Technical note

Project:	East West Rail - Bicester to Oxford	To:	Andy Milne
Subject:	CONDITION 19 - VSoA	From:	Inan Ekici
Date:	18 February 2015	cc:	Mike Fraser, Chris Brooks, Dan Bishop

CONDITION 19 – VIBRATION SCHEME OF ASSESSMENT

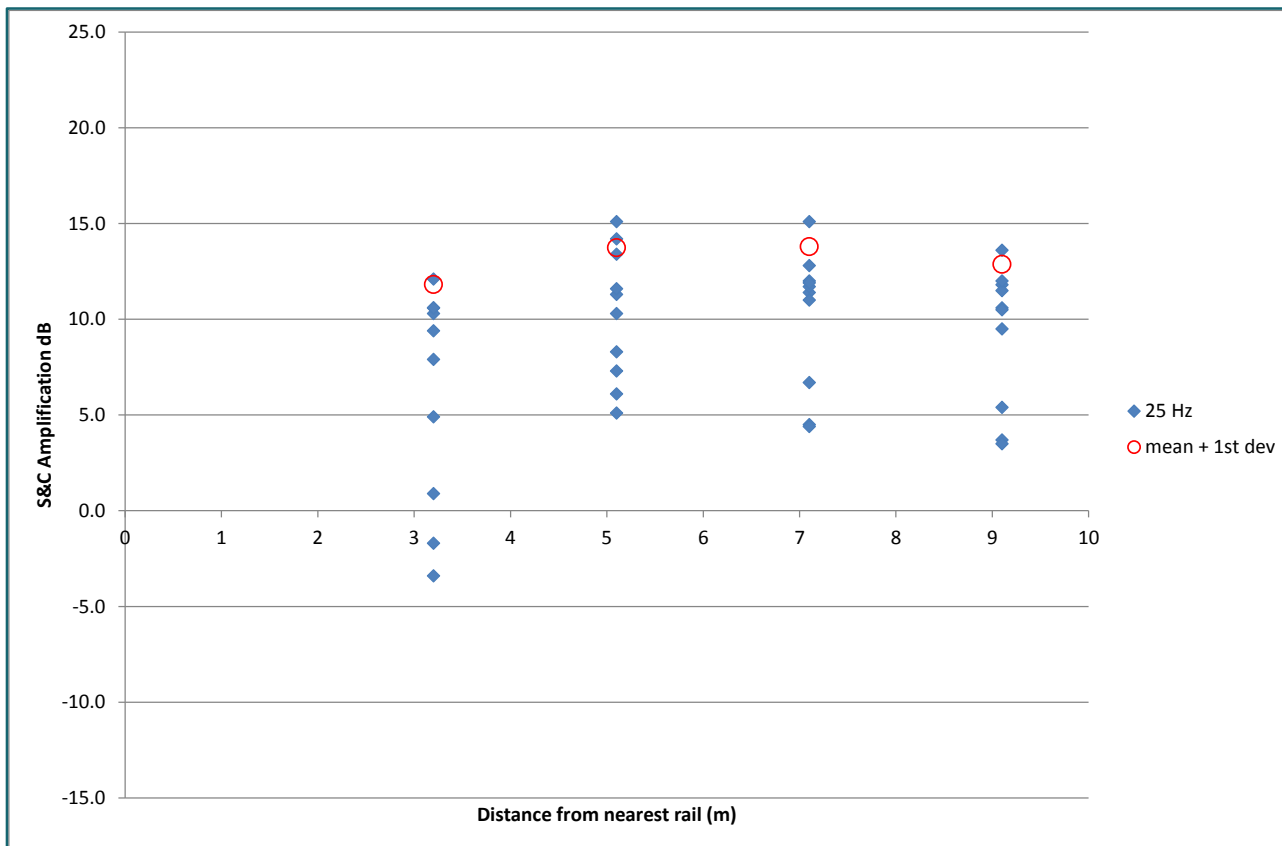
The assessments for S&C amplifications apply conservative assumptions in line with the rest of the assessments. For example, at 25Hz (original graph shown in Figure 42) where worst amplifications are noted, the assumed amplification factor of 12dB for freight trains represents 1 standard deviation above the measured mean value, as illustrated overleaf. It is shown that the measured amplification factors are lower than the assumed figures in the assessments in 90% of the cases.

It was shown as part of the plain line assessments that only 10% of the observed freight events are expected to exceed the assumed design curves. It is shown above that only 10% of the observed events are expected to result in amplification figures greater than those assumed in the S&C assessments at 25Hz. The assessments are based on conservative S&C amplifications being applied to conservative plain line levels cumulatively. Considering that the assessments for vibration from plain line and S&Cs already incorporate conservative assumptions, the use of a 'worst-case' transfer function between the outside and the inside of properties would result in overly conservative estimates. The assessments also assumed that the freight trains would travel at the design speed of 70mph through the area, when in reality this is likely to be lower (circa 50-60mph) due to the nature of freight rolling stock.

The original Scope Track Layout is shown in Figure 1 of VSoA Report 5114534-ATK-VIB-RPT-80003, Revisions A01, dated 21 January 2014 and is reproduced below.

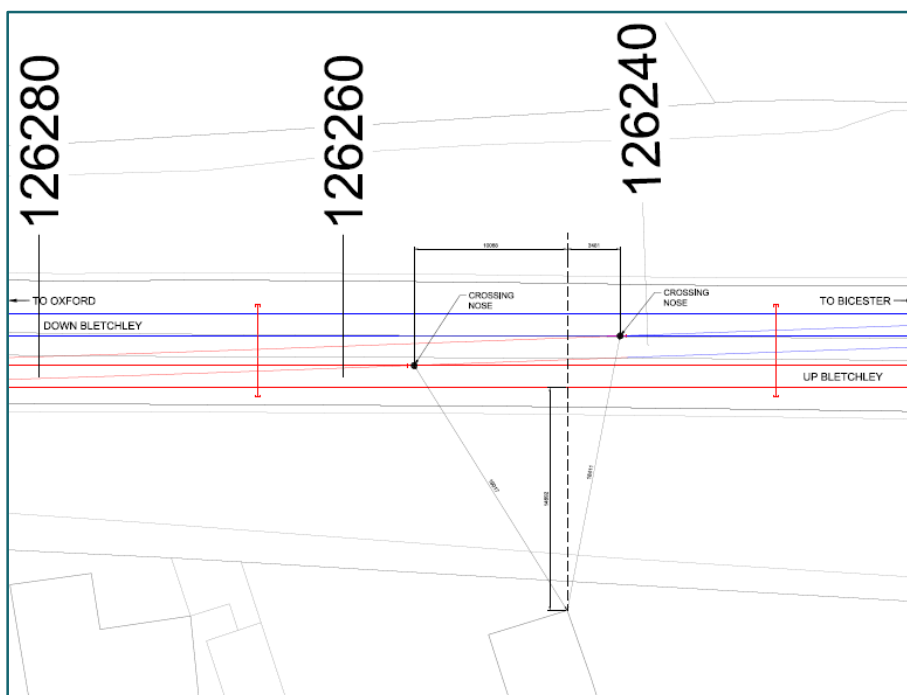
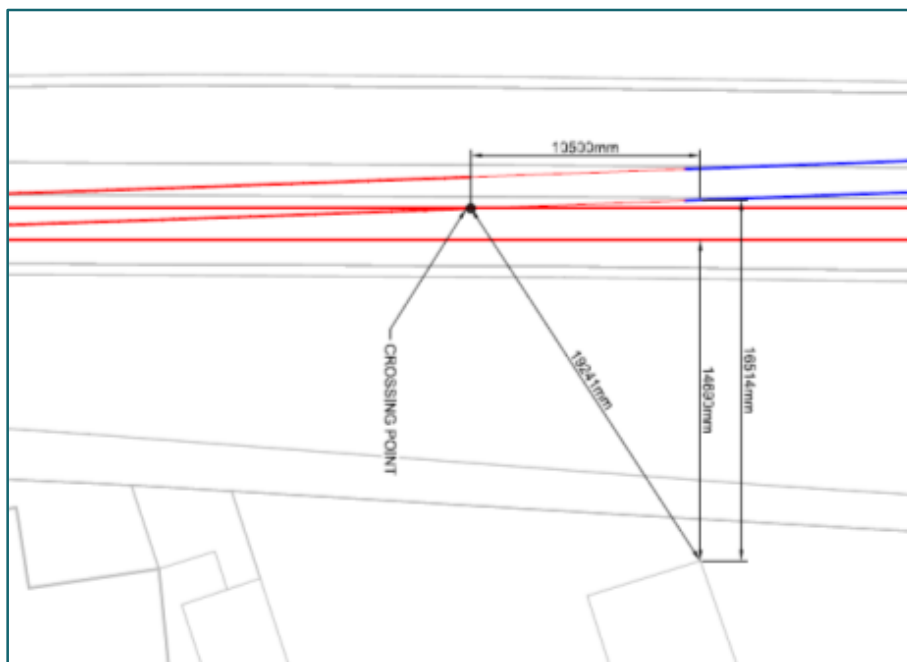
The VSoA Report is based on the original Scope Track Layout. The original Scope Track Layout comprised a 'single lead' junction where a single track from Oxford North Junction becomes two tracks before going through Wolvercot Tunnel. This 'lead' was called Woodstock Rd Junction.

As part of this original design, there was a single crossing point providing a 'discontinuity' in the track which could result in impact vibration. In line with the rest of the VSoA assessments, the assumption was that the up/down traffic would be split 50%-50% (i.e. equal traffic in both directions). The distance between the nearest property and the discontinuity is the same for traffic on both tracks at about 19.24m.

The revised track layout is for a two track railway throughout the Bicester to Oxford route. The lead previously at Woodstock Rd Junction becomes a “crossover” in a very similar position to the previous single lead. The extract from drawing number 5114534-ATK-DRG-MD-790200 below shows the revised layout in detail and the proximity to No. 4 Bladon Close.

The revised Scope Track Layout incorporates two discontinuities in the track. Both crossing points are marginally closer to the property (Up=19m and Down=18.4 compared to 19.24m previously). Based on distance considerations alone, the resulting vibration levels are not expected to be significantly different from those reported in the VSoA. The use of the crossover will be limited to abnormal working. On a day to day basis any one train will only pass over one nosing or discontinuity.

The design speeds for freight trains through the S&C as part of the original Scope Track Layout was 70mph on the nearside track (Track 1 in the calculations) and 60mph on the far-side track (Track 2 in the calculations). The design speeds in the revised Scope Track Layout are 75mph in each direction. As explained above, the maximum speed of freight trains is limited by their type. For instance stone trains are typically limited to either 50 or 60mph depending on the type of wagon in use. The dominant source of vibration is the near-side track. In accordance with the VSoA (Table 8), an increase in freight speeds from 70mph to 75mph is expected to result in a 5% increase in vibration levels.

The proposed S&C is a standard design and there is limited scope for changing the crossing nose geometry. It was recognised in the VSoA Report that the impact at the discontinuities is key to minimising vibration levels from the S&C and the resulting levels would be kept to a minimum by maintaining a good vertical and horizontal alignment throughout the design life of the crossing. This would ensure rail/wheel transition over the crossing point is as smooth as possible, and minimise levels of vibration generated.

The revised scope layout is expected to reduce the wear and tear and consequently impact and vibration, which would be experienced by the 'single lead' S&C by a factor of two due to sharing of traffic load between the two crossing points. In the long term the revised design represents an improvement (or reduction) in the expected impact due to vibration.
